Access Compliance Report Public Rights-of-Way (Pedestrian Signals)

Main Street: DANA_POINT_HARBOR_DR Cross Street: PUERTO_PL Location: SE

ADA ID: SGRK220208150317 Signal Type: One Push Button-APS Overall Compliance: No Severity Scores: BTN 1: 0 BTN 2: N/A No BTN: N/A

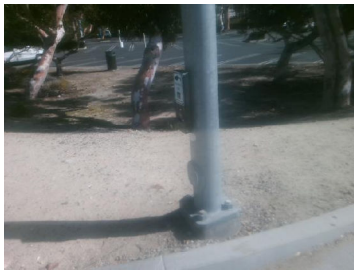
Yes	B 1 Diameter (in)	2	N/A	B 2 Diameter (in)	N/A
N/A	B 1 Crossing Direction	W	N/A	B 2 Crossing Direction	N/A
Yes	B 1 DistanceTo XWalk (in)	10	N/A	B 2 DistanceTo XWalk (in)	N/A
No	B 1 DistanceTo Curb (in)	80	N/A	B 2 DistanceTo Curb (in)	N/A

Possible Solutions: Replace Signal Push Button With APS Button. Remove & Relocate Sign.
